AGENDA  
HISTORIC PRESERVATION / DESIGN REVIEW COMMISSION

July 6, 2016 – 4:30 PM

# Administrative Staff Report

**Façade Improvement  
 Design Review Request  
 1059 Clark Street  
 June 28, 2016**

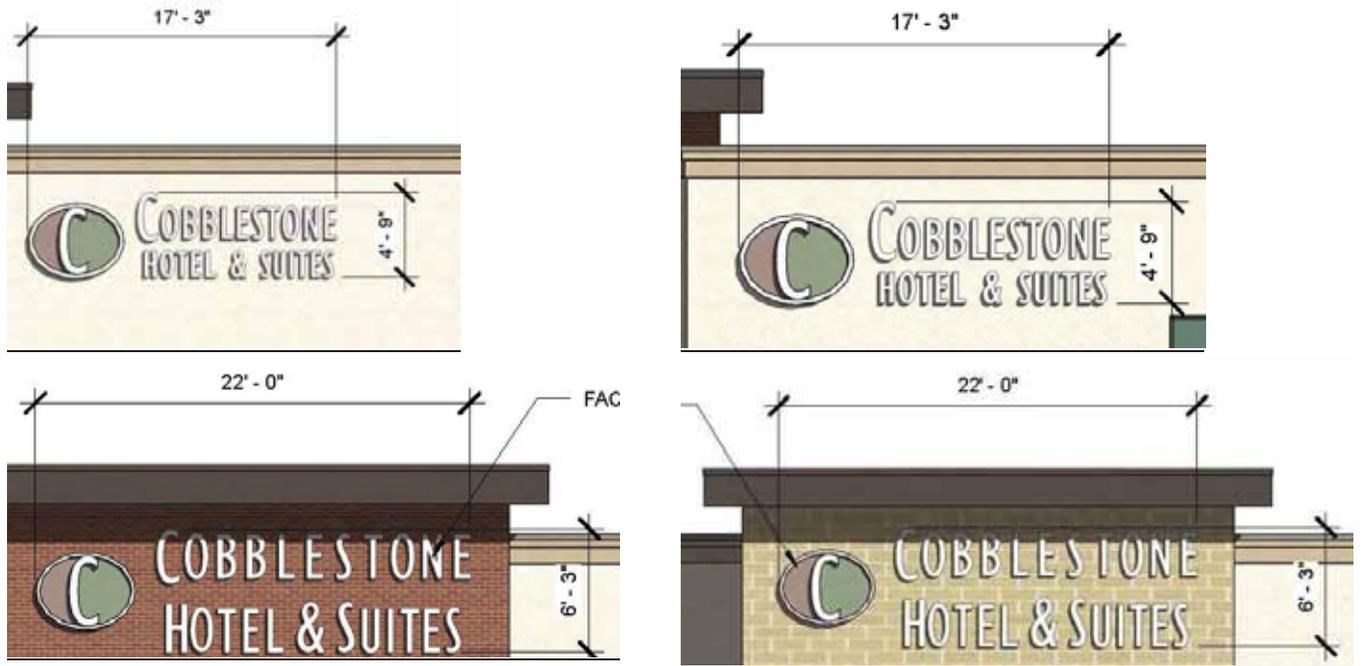
**Analysis:** Up-lighting in the form a wall sconces is proposed on the building (see attached photometric plan and specification sheet). Less than 1 foot candle is identified to spread off-site surrounding the development.

**Findings:** The intensity of light spreading to surrounding properties is minimal. Furthermore, the surrounding properties consist of other commercial establishments or municipal parking lots. While the lighting is of simple design, it should assist in accentuating the building design and architecture as well as signage.

COLOR ELEVATIONS

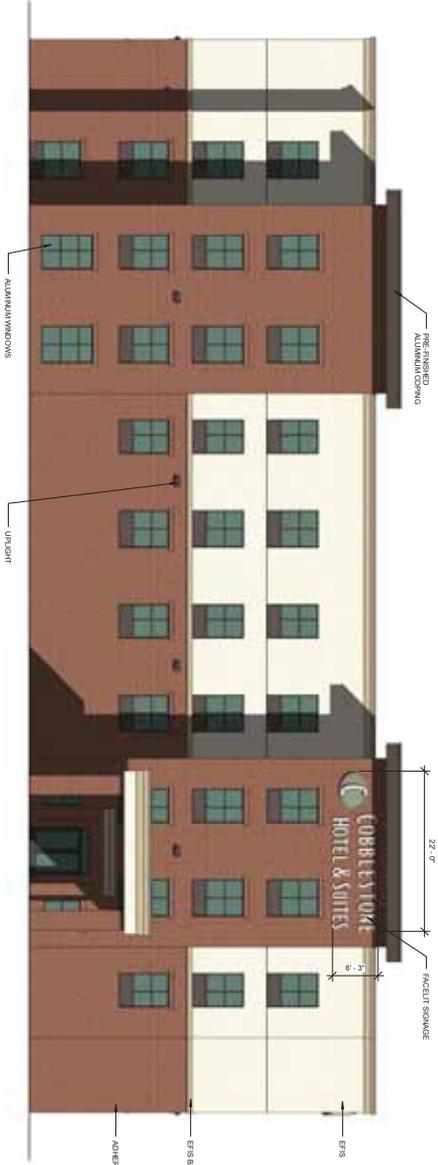
**Analysis:** Brick and stone veneer masonry materials are proposed on nearly two thirds of the façade. The remaining façade will consist of exterior finishing insulation system (EIFS) and windows. As indicated above, EIFS is proposed above the second floor.

**Findings:** The masonry components of brick and stone match that of surrounding buildings. While EIFS is not recommended as a façade material, especially for historic buildings, it is proposed on a portion of the third and fourth floors. The street level of the building will primarily be of masonry. Furthermore, EIFS will be difficult to distinguish on upper levels. Again the EIFS, not typically recommended, may be fitting in this instance given the new construction of the building and its location on the building. Furthermore, EIFS assists in providing a third color, element, and texture to the building, improving the design and appearance. EIFS was similarly used on the west neighboring building to add a design element and break up the monotonous façade.

SOUTH ELEVATION  
SCALE: 1/8" = 1'-0"

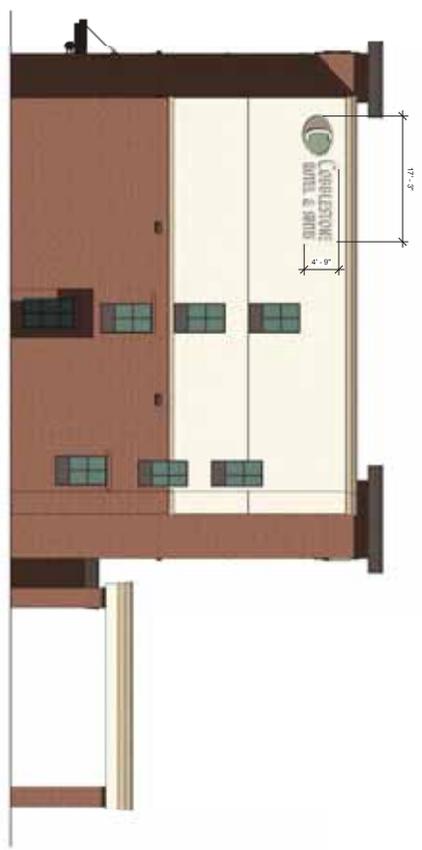
**Analysis:** Each building façade has an entrance. Furthermore, the south and east entrances will likely be utilized most. The east entrance faces Strongs Avenues and has a canopy for patrons to utilize when checking-in and unloading.

**Findings:** The primary entrance faces public right-of-way and allows for easy access. Note also that a pedestrian walkway will exist west of the proposed building to assist in connecting the downtown with property to the north.
